MD-MS (DM-2000) Desk Top Microphone Monitor Rework Instructions

Modification Note

Item: DM-2000 Desk top microphone

Issue: Monitor function error causes various consoles to lock MON into the down position.

Step 6 Version 1 only.Version 2 starts on page 5

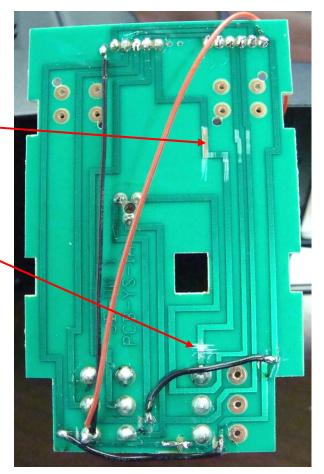
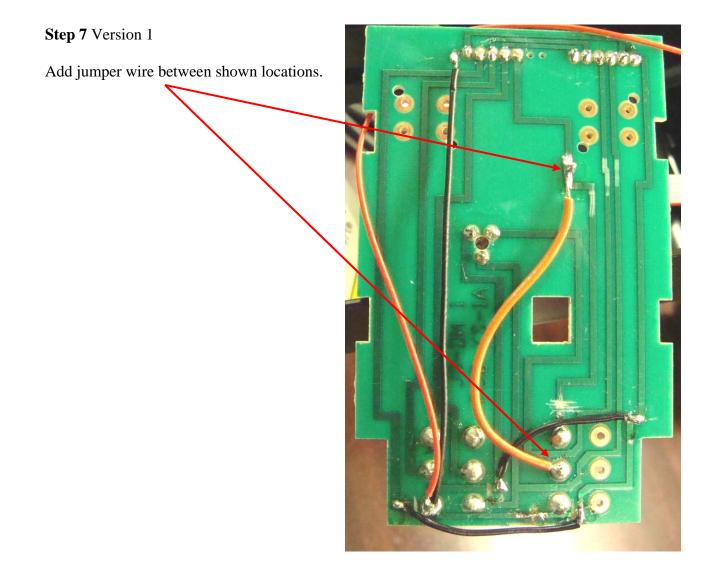
On bottom of PCB complete the following:

Scratch/remove solder mask

Cut trace

Step 6 Version 2 only.

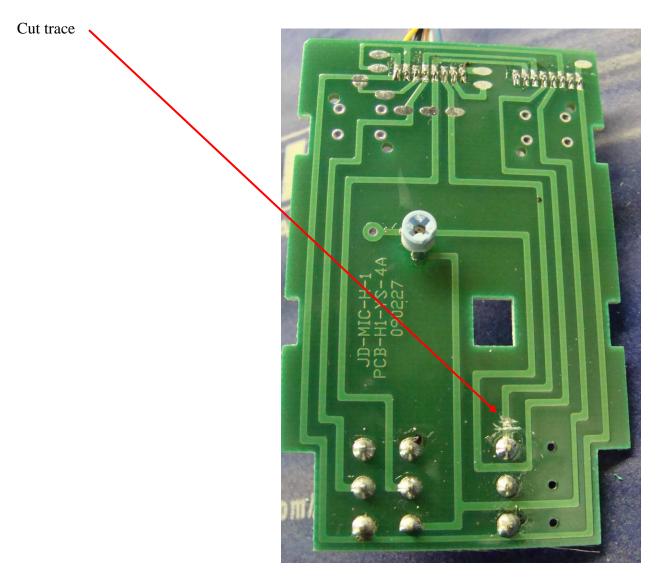
On bottom of PCB complete the following:

Step 7 Version 2

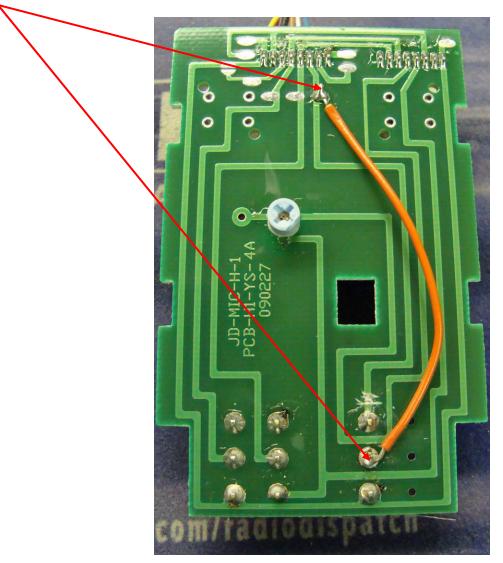
Add jumper wire between shown locations.
